STANDARD DEPARTURE CHART-INSTRUMENT

RJFN / NYUTABARU

SAITO ONE DEPARTURE

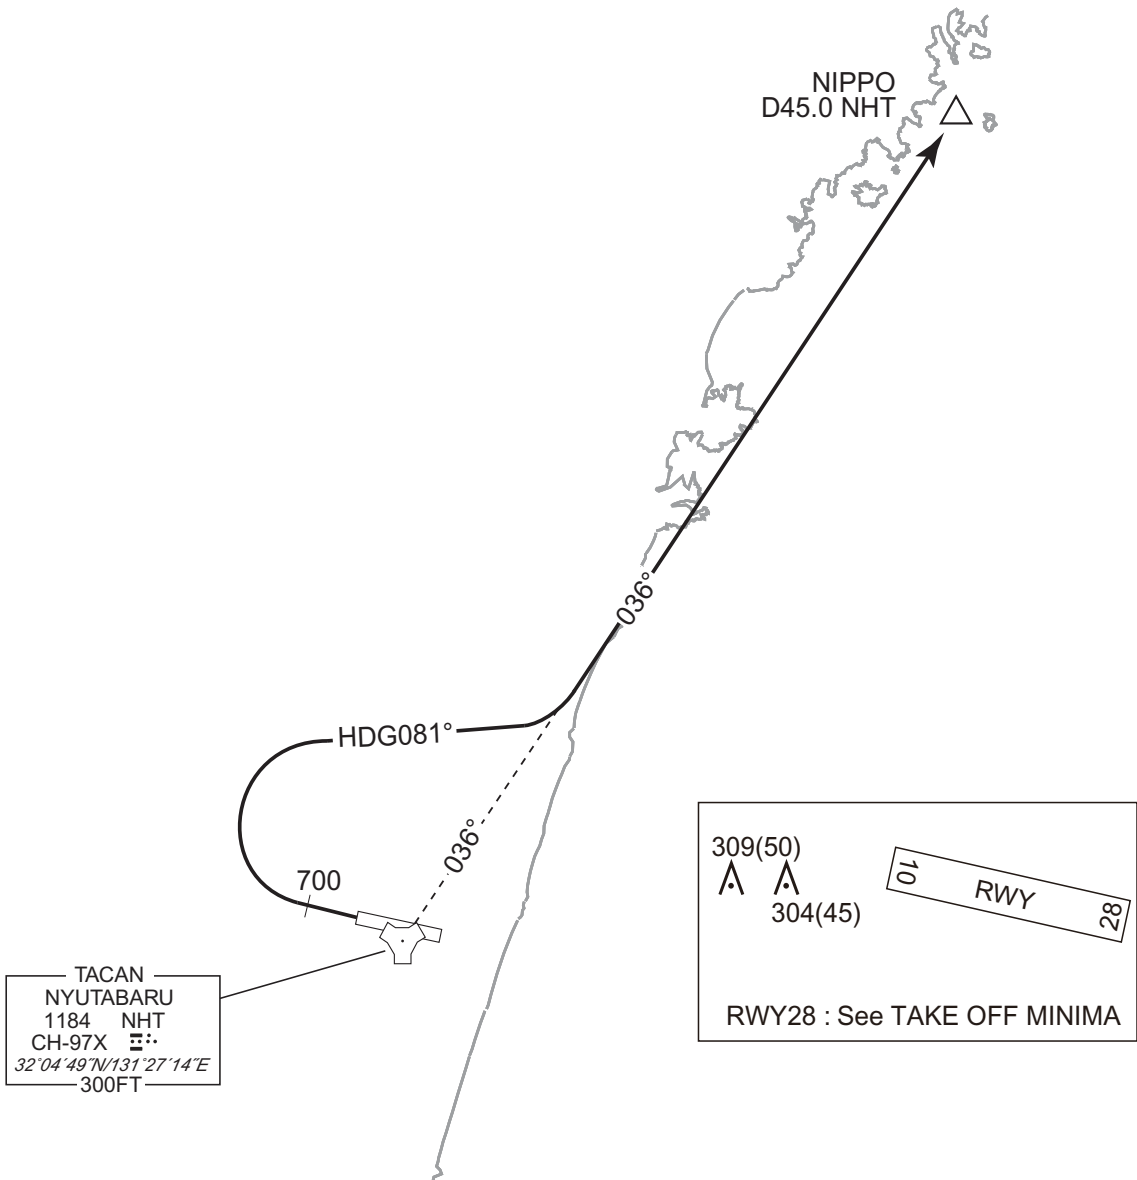
CHANGE : New PROC.

- RWY10 : (Not established)
- RWY28 : Climb RWY HDG to 700FT, turn right HDG 081° to intercept and proceed via NHT R036 to NIPPO.

TRANSITION

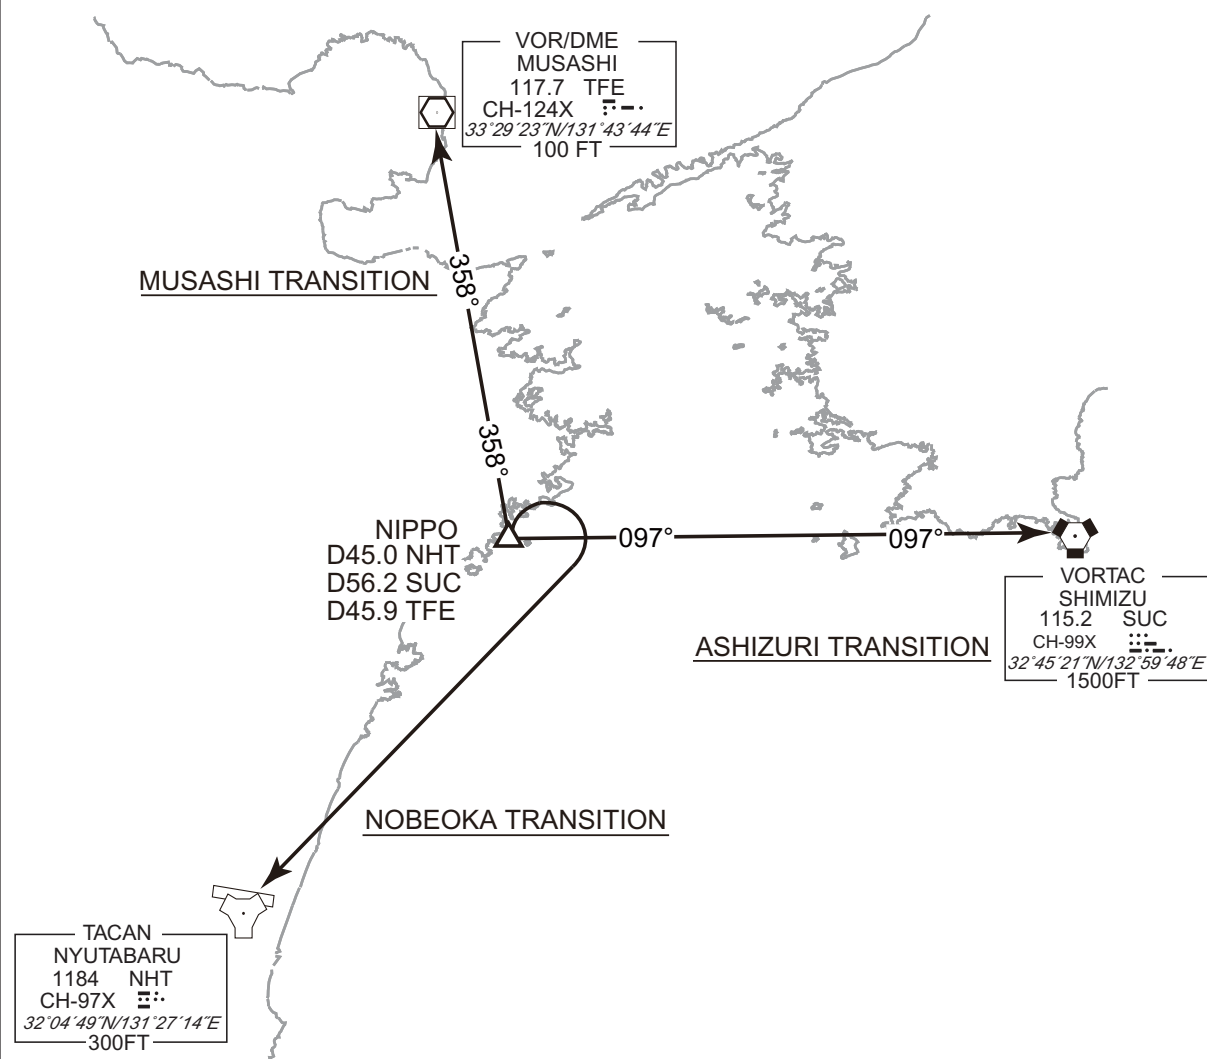
CHANGE : PROC course(NOBEOKA TRANSITION). Description of ASHIZURI TRANSITION, MUSASHI TRANSITION, MUSASHI TRANSITION. ALT restriction.
SOBO TRANSITION abolished.

TENSO ARRIVAL

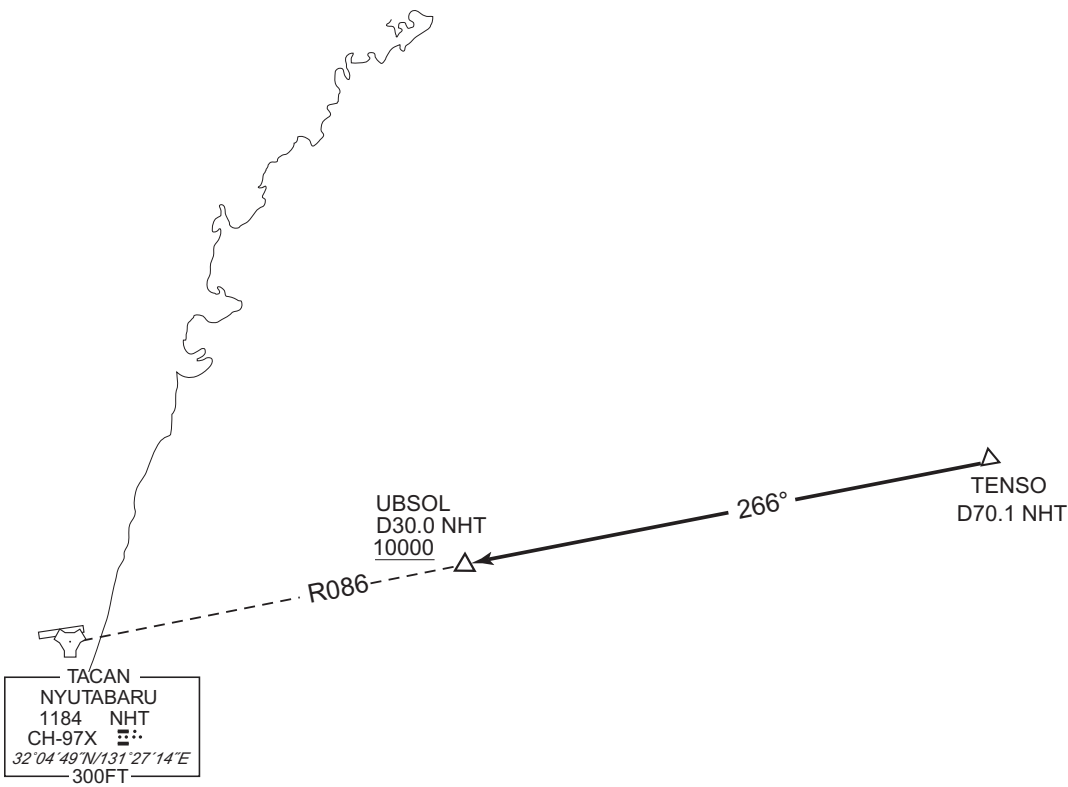
CHANGE : PROC course. UBSOL established. ALT restriction.

From over TENSO, via NHT R086 to UBSOL.
Cross UBSOL at or above 10000FT.

TACAN Z RWY28

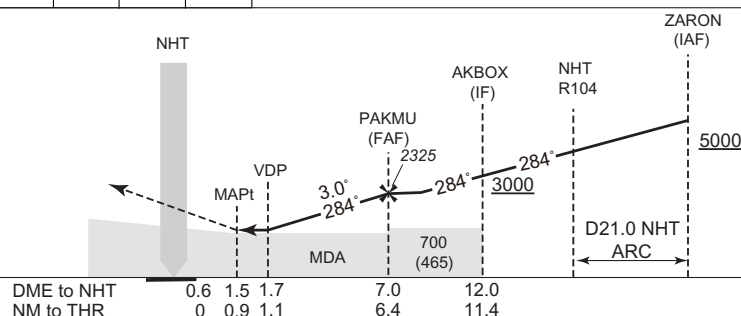
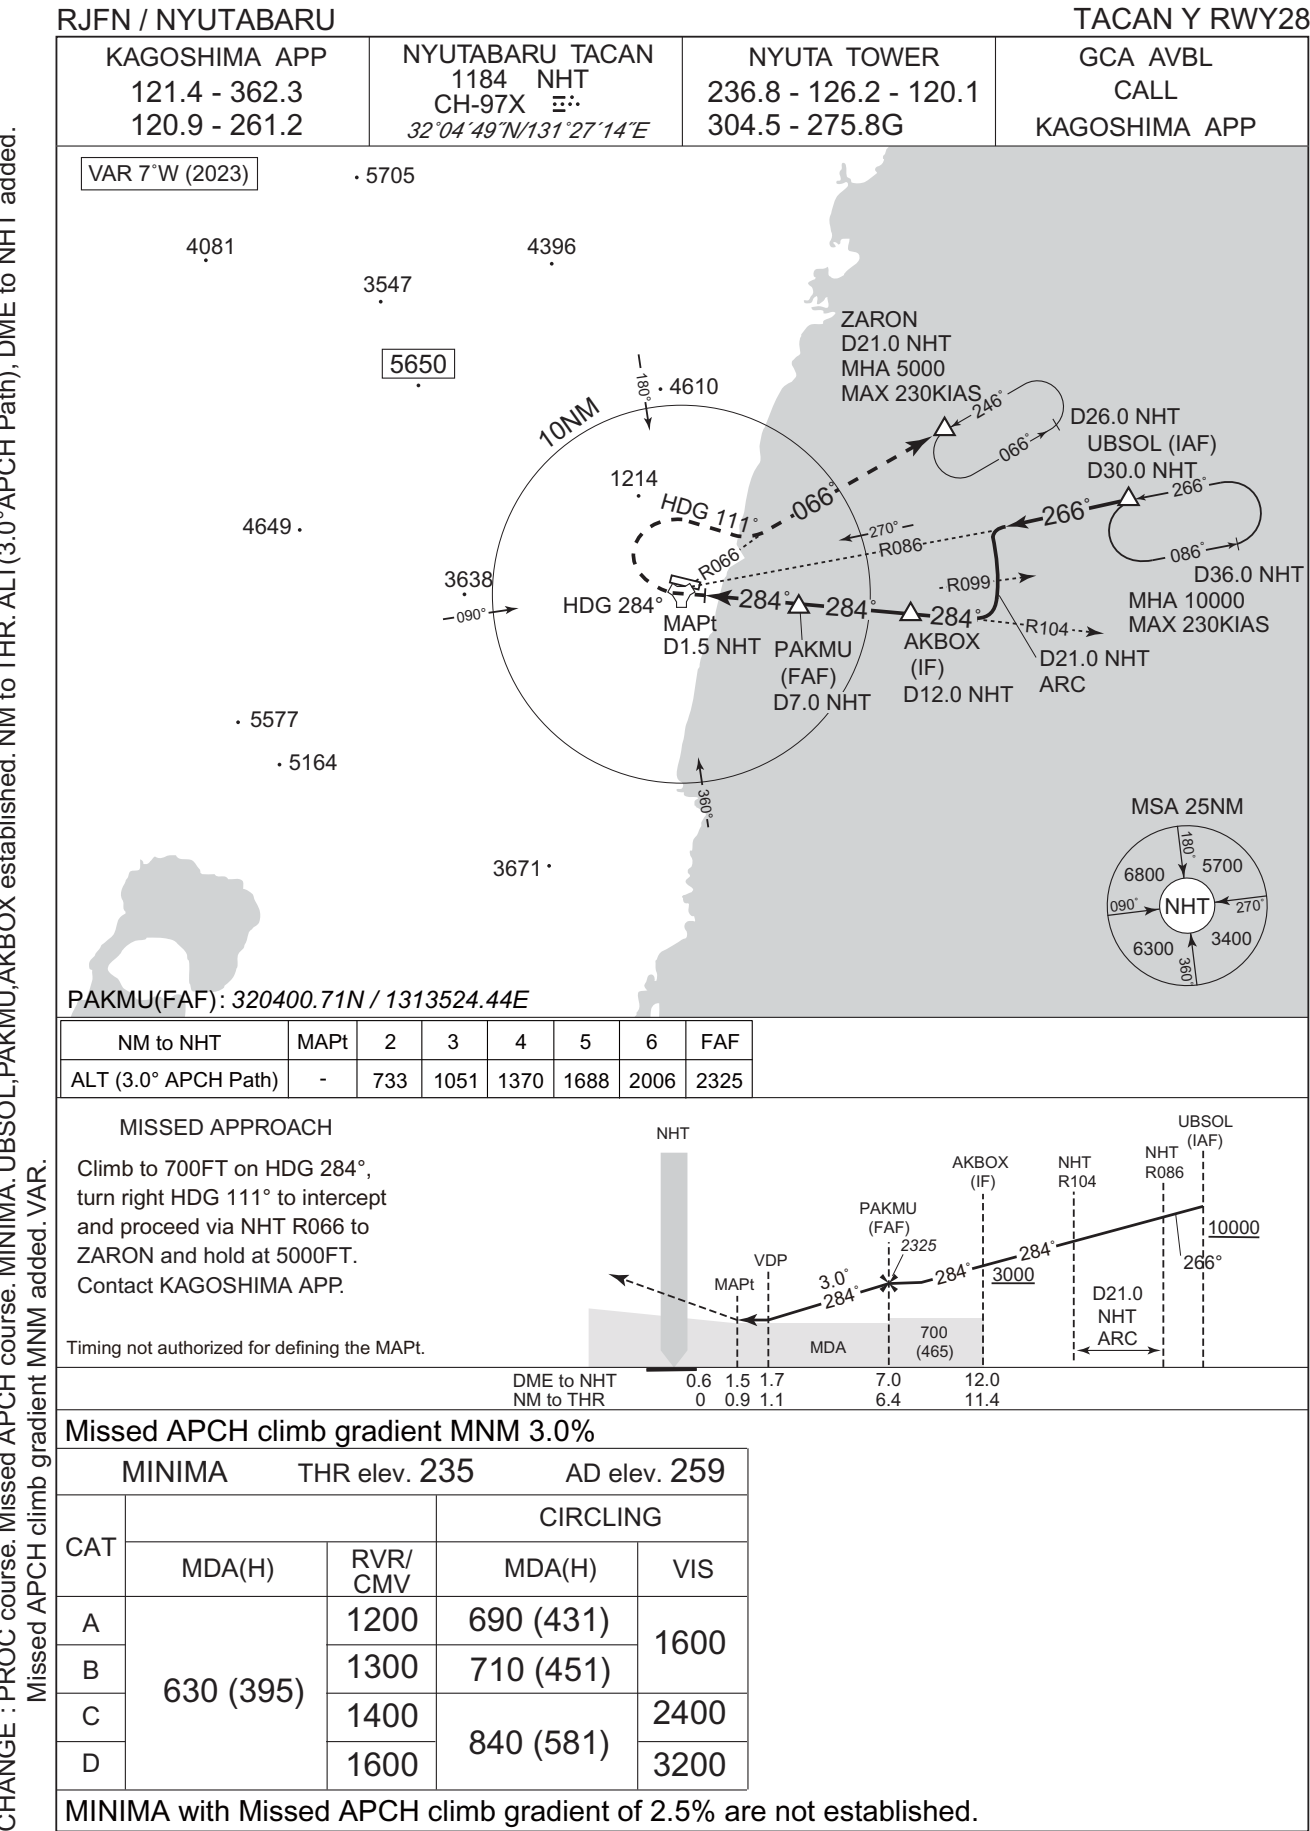
CHANGE : PROC course. Missed APCH course. MINIMA. PAKMU,AKBOX established. NM to THR.ALT(3.0°APCH Path), DME to NHT added. Missed APCH climb gradient MNM added. VAR.

Climb to 700FT on HDG 284°,
turn right HDG 111° to intercept
and proceed via NHT R066 to
ZARON and hold at 5000FT.
Contact KAGOSHIMA APP.

Missed APCH climb gradient MNM 3.0%

ILS Y or LOC Y RWY28

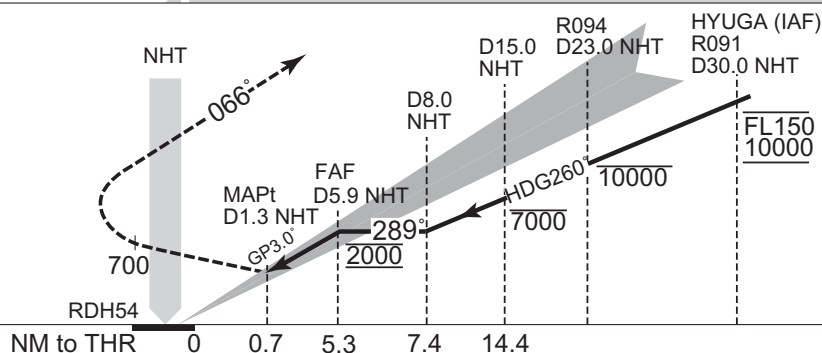
CHANGE : VAR. PROC renamed. EQPT REQUIRED added. PROC course. MISSED APPROACH course. MSA.
NM to THR added. MDA(H) for CIRCLING.

Climb to 700FT, turn right
climb via NHT TACAN R066 to
ZARON to 5000FT and hold.
Contact KAGOSHIMA APP.
